Planning Commission Staff Report

MEETING DATE: JANUARY 6, 2021

SUBJECT: DR20-144, PARK LUCERO EAST

1 NORTH ELEVATION - BUILDING B
SCALE: 1" = 30'-0"

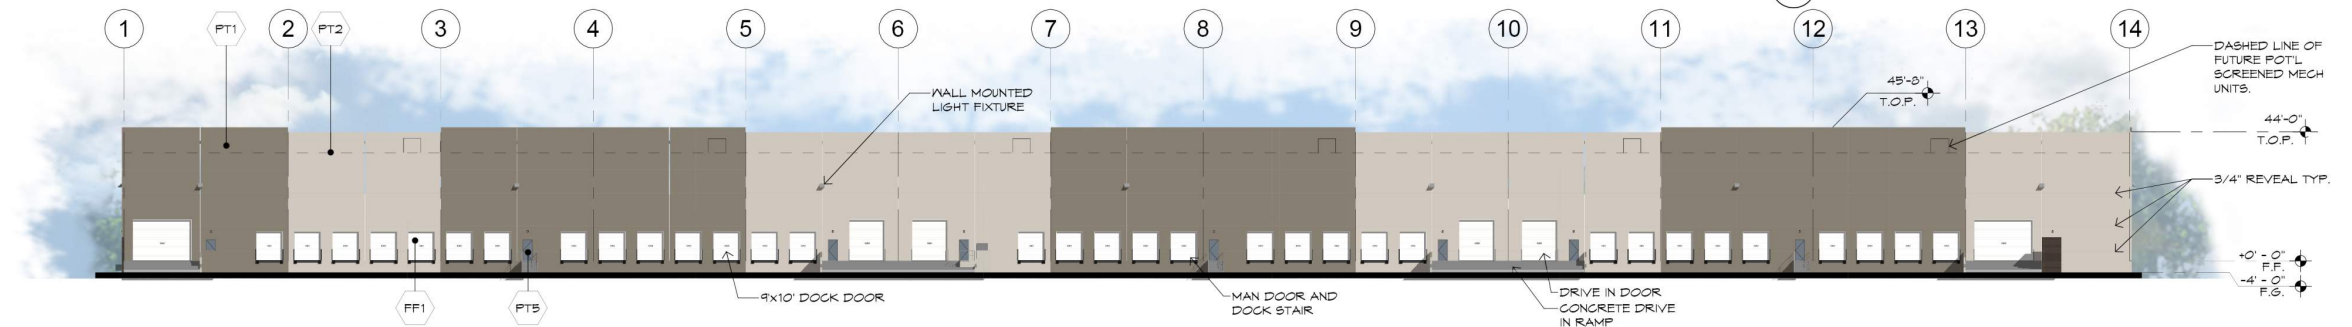
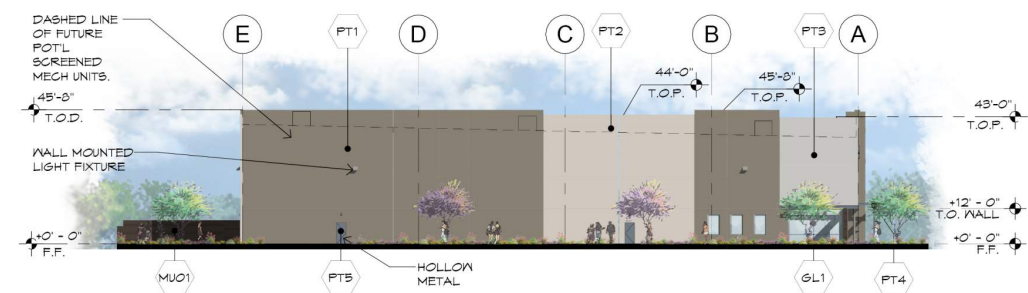
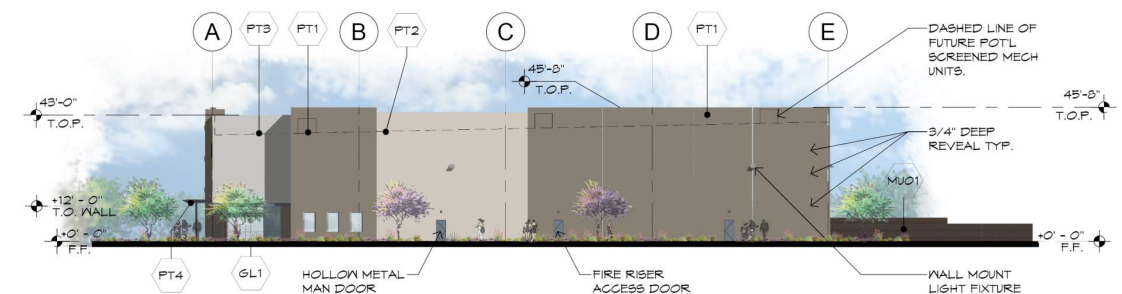
- The Commission inquired about the specific findings required to allow building mounted lighting above 14' and were generally supportive of the request, subject to the findings being met.
- The Commission expressed concern over the north elevations (rear) for Building C facing the freeway due to the high visibility of the elevation. It was suggested that additional architectural enhancements be added to the elevations; suggestions included additional articulation of the roofline and that additional colors and materials be applied to the elevation.
 - *The applicant modified the north elevation of Building C to address staff and the Commission's concerns by applying 2' of additional articulation to the roofline and adding decorative color blocking in a geometric design across the entire building elevation.*

Chair Bloomfield looked at the north side facing the freeway. It is a look we don't see anywhere else in the town on the freeway. In Park Lucero West, it is the front of the building where customers enter, where this will be back of house and filled with semi-trucks. There will be 8' site walls although it may be seen looking down from the freeway. His only question was whether it meets the guidelines and requirements of the town.
